Re: Updated Project Submission
Project Name: 760-790 Center Street Mixed-Use Development
Applicant/Project Sponsor: 1200 Group, LLC c/o Ellicott Development Co. (EDC)

PLANNING BOARD MEETING MINUTES DATED 7/13/2026:

STANDARD DUTY ASPHALT SECTION - 4A

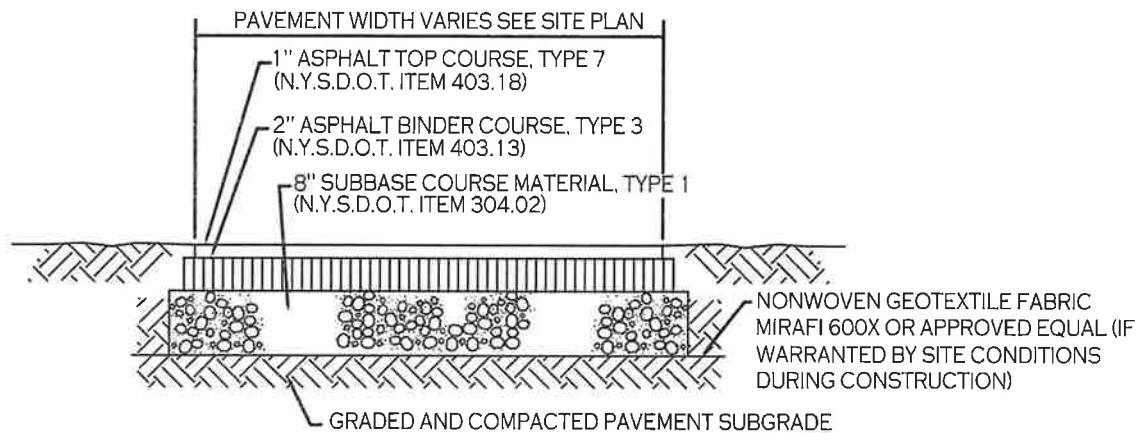
b. All pavement on site is indicated as "Standard Duty". What is that pavement section and can it withstand truck traffic?

Below is a copy of the Standard Duty Asphalt Section as included on Drawing C-101 (dated 7/11/2016) in our civil drawing set in connection with our building permit application, which was later issued on 7/18/2019. This asphalt section complies with NYSDOT Standard Specification 401-3 and is sufficient to withstand the size and frequency of truck traffic on the Project Site.

1
A101
CONCEPT FIRST FLOOR PLAN
SCALE: 1/8" = 1'-0"

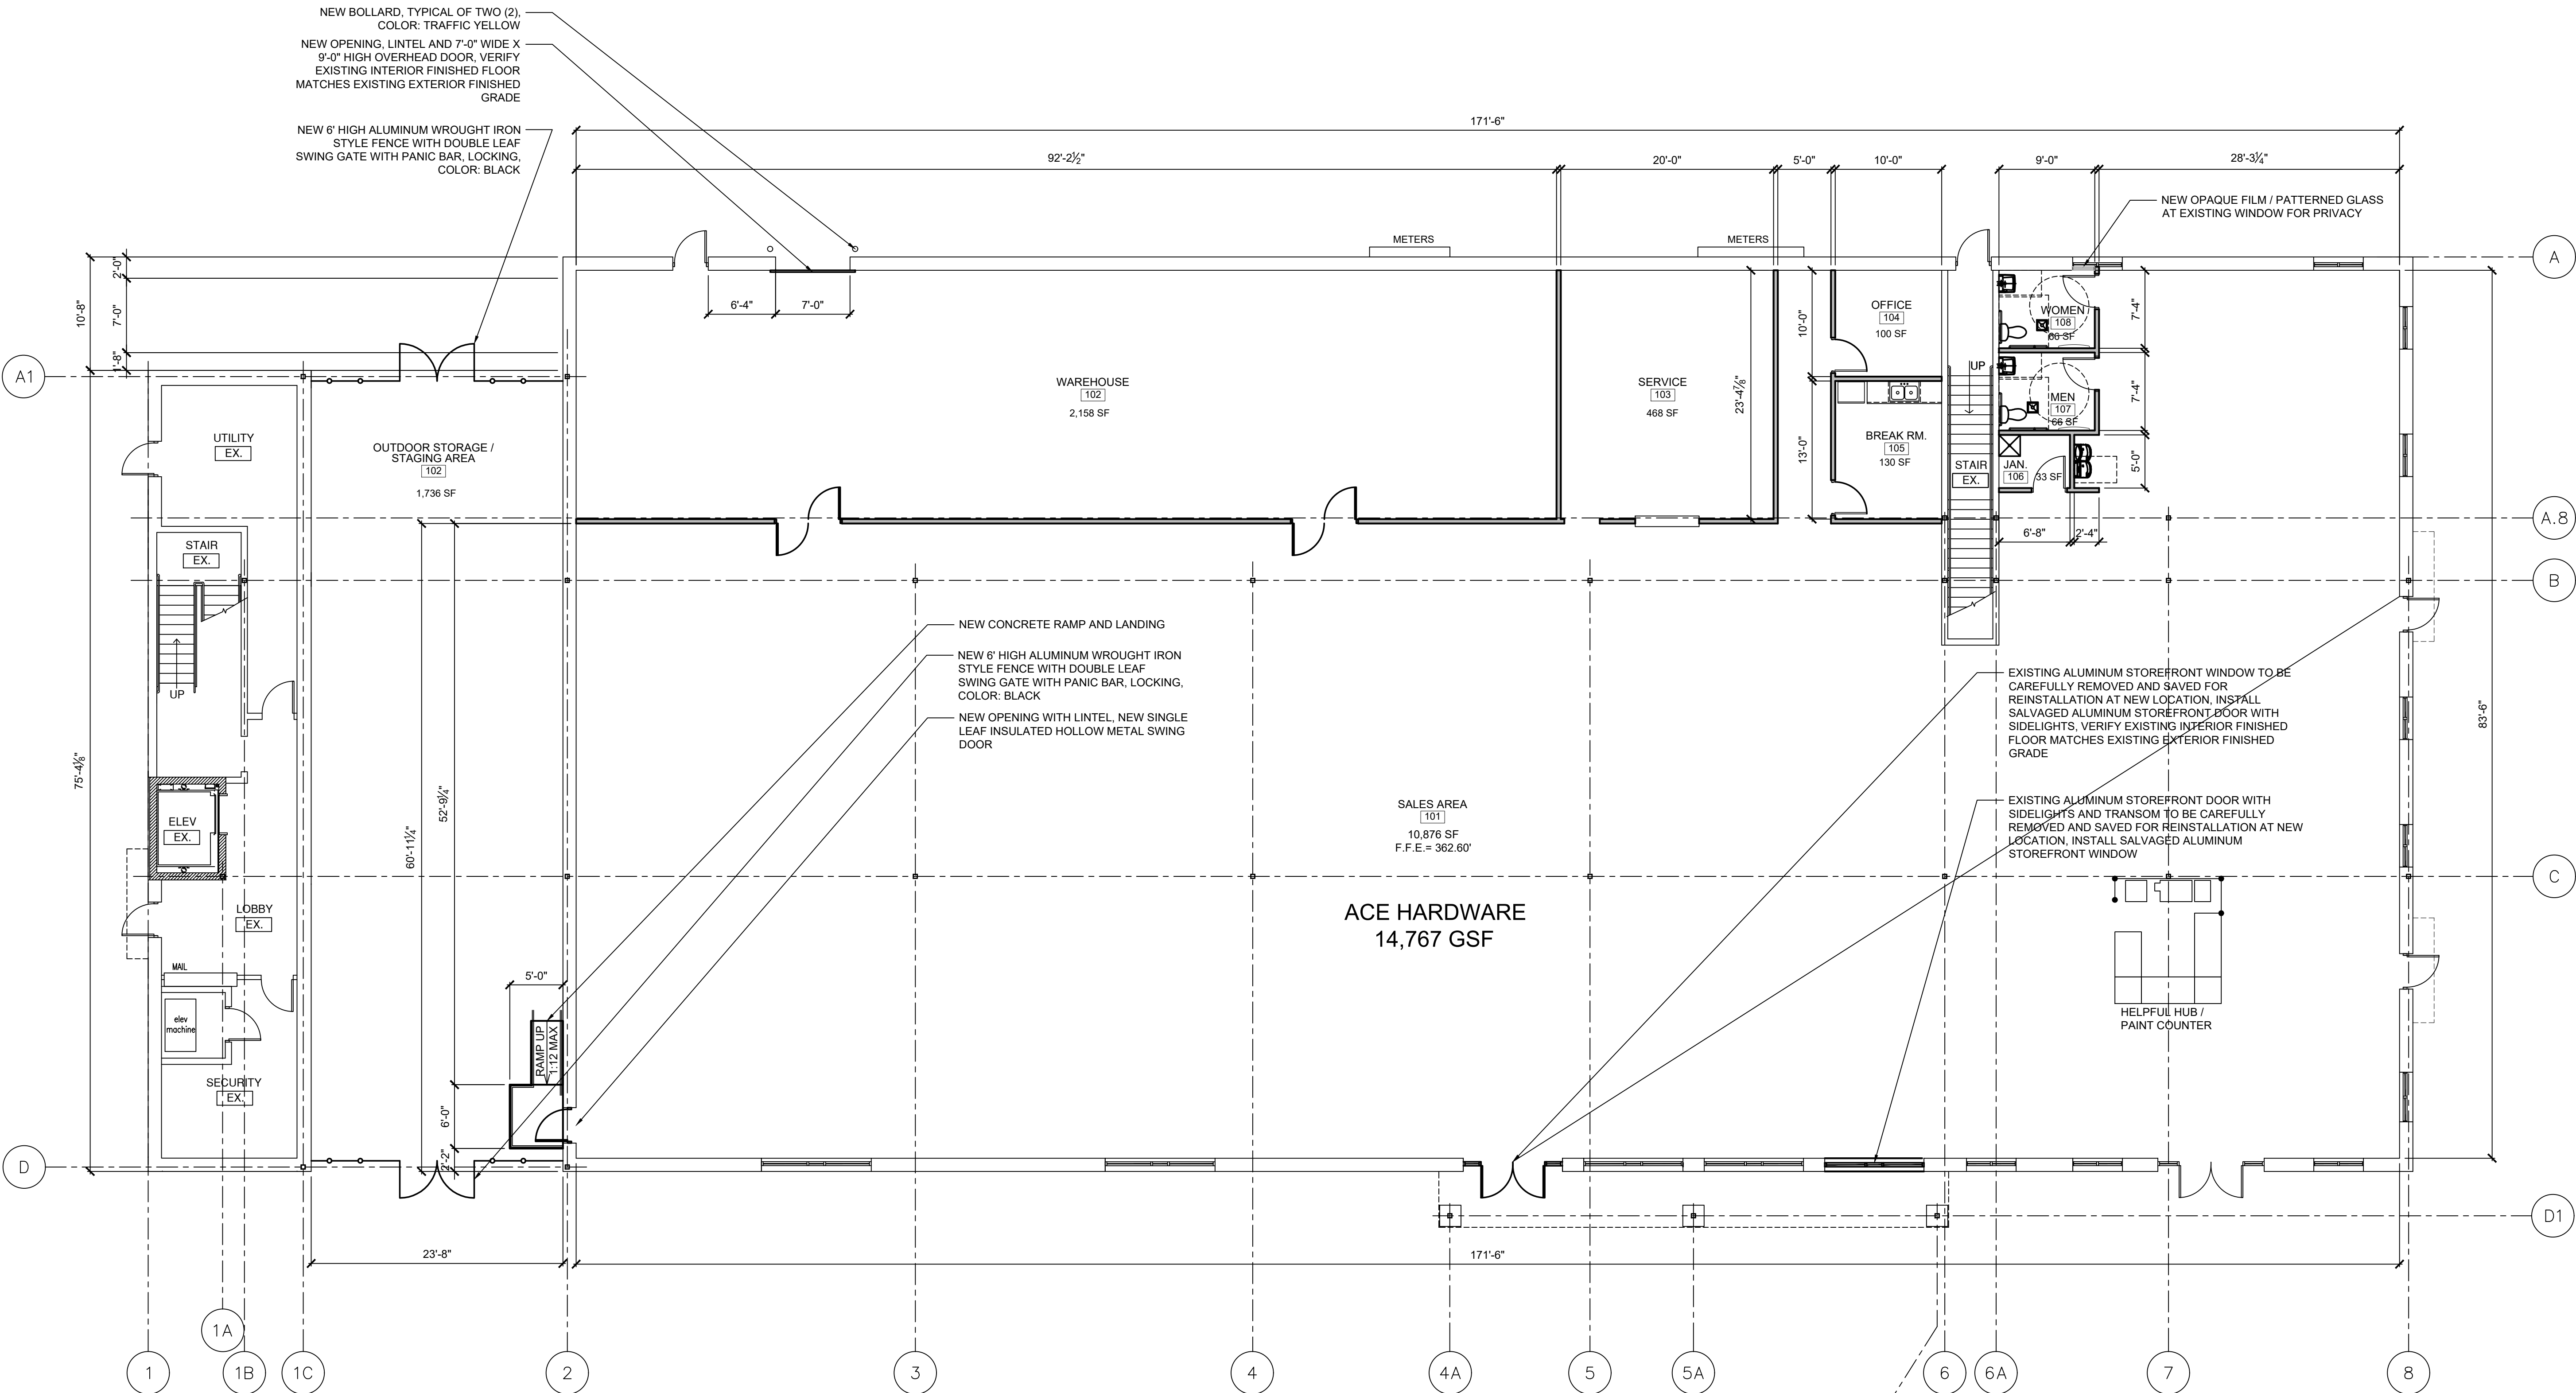
1. With respect to the main entrances into the retail space on the south elevation of Building 3, the proposed main entry points have been reduced from 3 to 2. See Floor Plan Drawing A101, dated 8/31/2026, attached as Exhibit "1". The existing two-leaf entry on the east end of the south elevation between column lines 7 and 8 would remain as is. The existing two-leaf entry between columns 5A and 5B, would be relocated to the west between column lines 4A and 5. Also see Building Exterior Elevations Drawing A201, dated 8/31/2026, attached as Exhibit "2".

2. With respect to the covered drive-thru space, this area will no longer be enclosed for an expansion of interior space, as this is not needed by the proposed tenant. Instead, the area is proposed to be utilized for the storage and staging of outdoor merchandise. As shown on Drawings A101 and A201, attached as Exhibits "1" and "2" respectively, the south and north openings into this space are proposed to be closed off with a 6' high, black decorative aluminum fence with center positioned swing gates for exterior access.

The covered and fenced outdoor space would also be accessible via a new single-leaf man door located near the southwest corner of the tenant's interior space.

3. For merchandise deliveries into the proposed interior warehouse/stock area, the proposed roll-up loading door has been relocated on the north elevation to between column lines 2 and 3. See Drawings A101 and A201, attached as Exhibits "1" and "2" respectively.

Site Plan

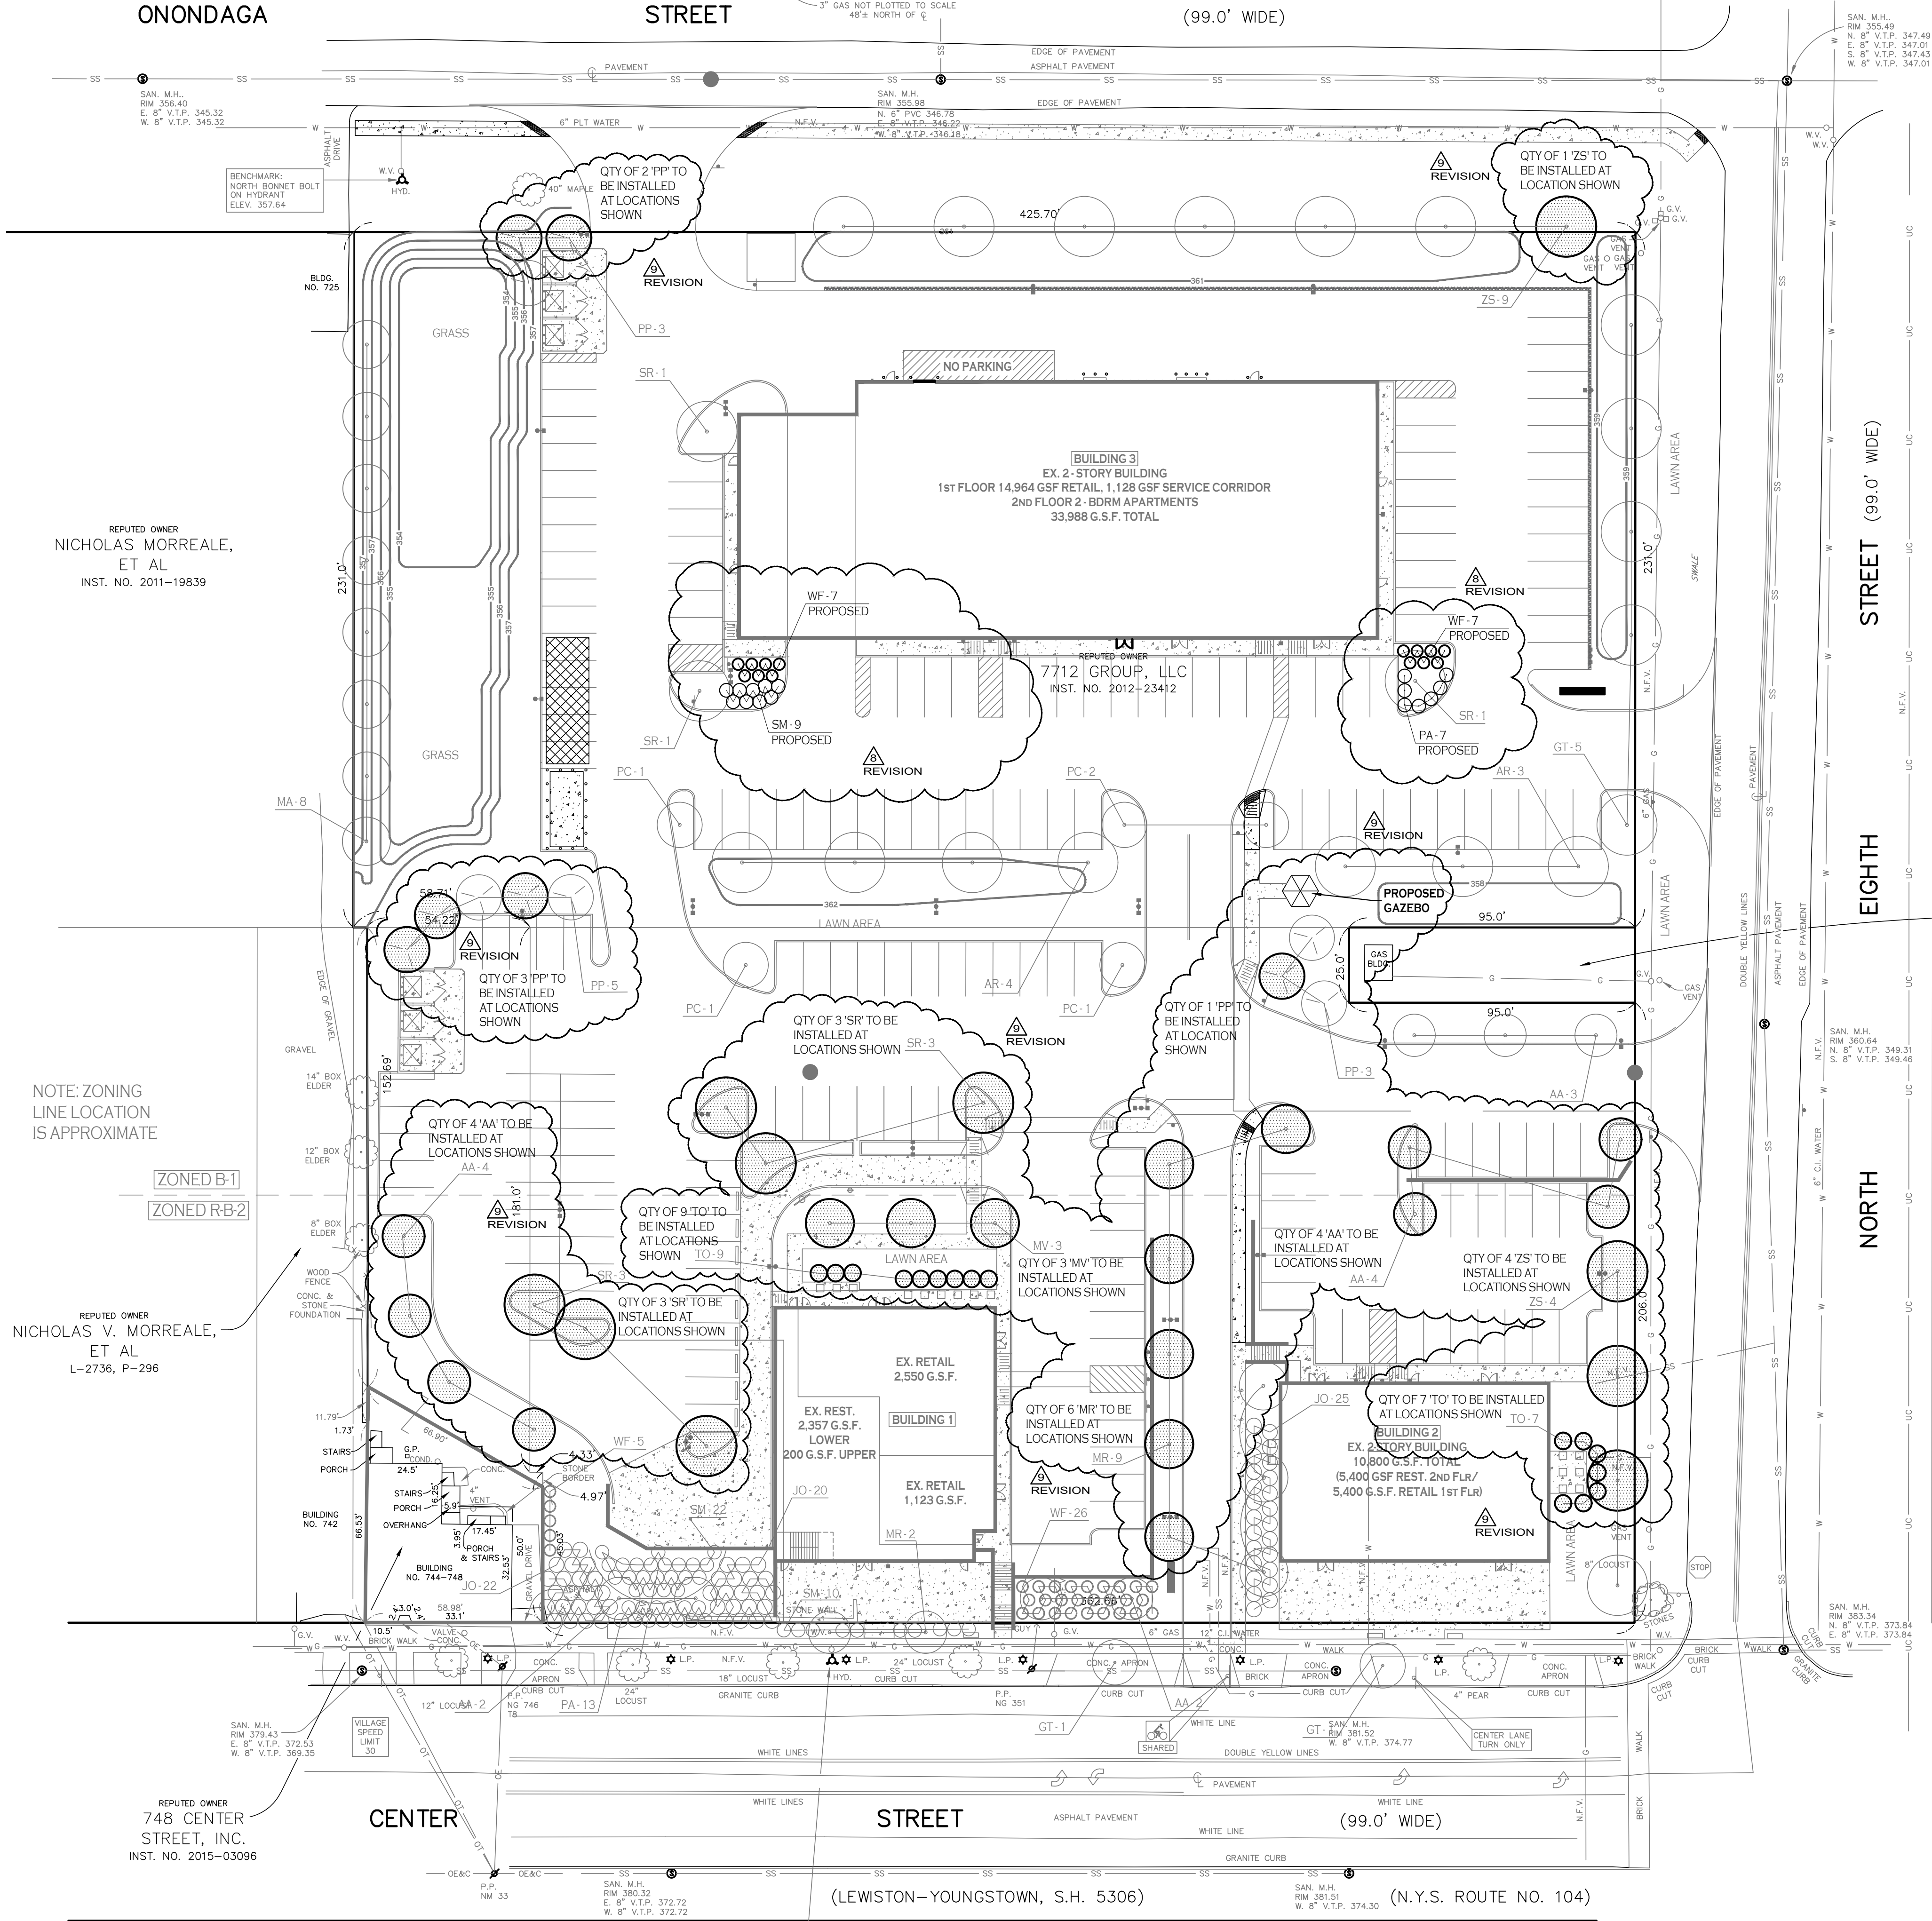
a. Previous approvals included a sidewalk connection from Building 3 to the sidewalk on Onondaga Street. None is shown on the plans and should be included.

b. The sidewalk on Onondaga Street has no tactile warning at its terminus with N. 8th Street or at the site drive. These must be added.

c. The sidewalk on the west side of the drive to Onondaga Street was never constructed.

d. Original plans showed a sidewalk along the west side of N. 8th Street. It has subsequently been removed. Why?

a. If the commercial space is to be a Hardware Store, will there be propane sales? If so, where will propane storage be located?

b. Access on the south side of Building 3 shows a new island for pedestrian access from the south. It should be included as part of the revision on the site plan and be dimensioned.

c. Handicap parking and access is shown on the west side of the existing western door on the south side of Building 3. Ramps are currently located at the new island and further to the west. Will the existing ramps be relocated/removed?

d. Man doors located on the North side of Building 3 open directly to the access drive. Protective bollards should be installed.

During the 7/13/2026 Planning Board meeting, a comment made requesting consideration of a sidewalk connection from Building 3 to the existing sidewalk on Onondaga Street. This section of sidewalk has not been included in the updated submission given the steep topography in that portion of the Project Site and the resulting inability to comply with ADA standards for slope.

EDC will install the portion of sidewalk at the northwest corner of the Project Site along Onondaga Street between our existing driveway entrance and 725 Onondaga Street to the west. This has been reflected on the Updated Site Plan (C-100, dated 9/1/2026, attached as Exhibit "3").

EDC will install tactile warning strips where necessary on the sidewalks along Onondaga Street. This has been reflected on the Updated Site Plan (C-100, dated 9/1/2026, attached as Exhibit "3"). The originally proposed sidewalk along N. 8th Street was removed from the plan based on conversations with National Fuel. The construction of this sidewalk was prohibited by National Fuel as they do not allow the construction of sidewalks over their high-pressure lines, which run down the west side of N. 8th Street.

Response: Yes, the proposed tenant is proposing to have propane sales. The proposed propane refill tank would be located in the western row of parking spaces, as shown on the attached Updated Site Plan (see C-100, dated 9/1/2026, attached as Exhibit “3”).

Response: The Updated Site Plan reflects the current conditions; (see C-100, dated 9/1/2026, attached as Exhibit “3”).

Response: The existing ramps on the south side of Building 3 will not be relocated or removed. The previously submitted plans in connection with this pending request for Amended Site Plan approval did not accurately reflect the as-built condition. The as-built condition is now accurately reflected on the Updated Site Plan (C-100, dated 9/1/2026, attached as Exhibit “3”).

Response: Protective bollards will be installed at both man doors and electrical meters along the North Side of Building 3. This has been reflected on the Updated Site Plan (C-100, dated 9/1/2026, attached as Exhibit “3”)
